Access Compliance Report

Public Rights-of-Way

(Curb Ramps)

Intersection ID: 54465	Main Street: RUPELL_DR	Cross Street: COLLINGHAM_DR	Location: SE
ADA ID: 0DBBFF5A6BE9	Ramp Type: BlendTrans1	Initial Pass/Fail: Fail	Overall Compliance: No
		Severity Score: 10

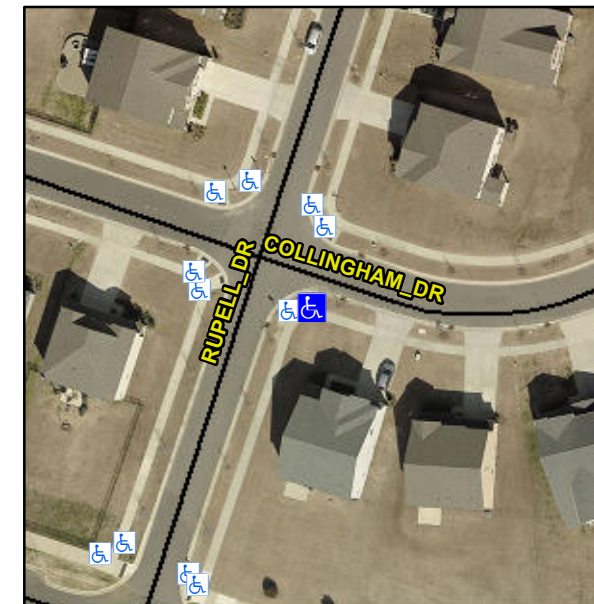
Not Found, R304.5.1, R304.5.3

Compliance	Description	Data	Compliance	Description	Data
N/A	Ramp Length (in)	95.0	Yes	BlendTrans Slope (%)	4.3
No	Ramp Width (in)	46.0	No	BlendTrans XSlope (%)	2.2
N/A	Flare Type LT	N/A	N/A	Flare Type RT	N/A
N/A	Flare Slope LT (%)	N/A	N/A	Flare Slope RT (%)	N/A
N/A	Flare Traversable LT?	N/A	N/A	Flare Traversable RT?	N/A
N/A	Landing Length (in)	N/A	N/A	DWS Provided?	N/A
N/A	Landing Width (in)	N/A	N/A	DWS Contrast?	N/A
N/A	Landing Slope (%)	N/A	N/A	DWS Length (in)	N/A
N/A	Landing X Slope (%)	N/A	N/A	DWS Full Width?	N/A
N/A	Landing Curb? (Y/N)	N/A	N/A	DWS Offset (in)	N/A
N/A	Shared Landing?	N/A			
N/A	Gutter Ponding?	N/A	N/A	Gutter Slope (%)	N/A
N/A	Gutter Lip Ht (in)	N/A	N/A	Gutter X Slope (%)	N/A
N/A	Painted X Walk1?	No	N/A	Painted X Walk2?	N/A
	X Walk 1 Direction	To NE		X Walk 2 Direction	N/A
	X Walk 1 Width (in)	N/A		X Walk 2 Width (in)	N/A
	X Walk 1 Slope (%)	2.5		X Walk 2 Slope (%)	N/A
	X Walk 1 X Slope (%)	0.5		X Walk 2 X Slope (%)	N/A

N/A	Ramp inside XWalk1?	N/A	N/A	Ramp inside XWalk2?	N/A
	Road Slope (%)	0.5		Clear Space?	N/A
	Road X Slope (%)	2.5	N/A	Clear Space to XWalk (in)	N/A
N/A	Any Obstructions?	N/A	N/A	Storm Grate/Utility Hazard?	N/A
	Obstruction Type			Storm Grate/Utility Type	
		N/A			N/A
			Yes	Surface Condition? (G/P)	Good
			No	Curb Slope (%)	8.8

Remove & Replace Curb Ramp With Two New Directional Ramps or Equivalent.
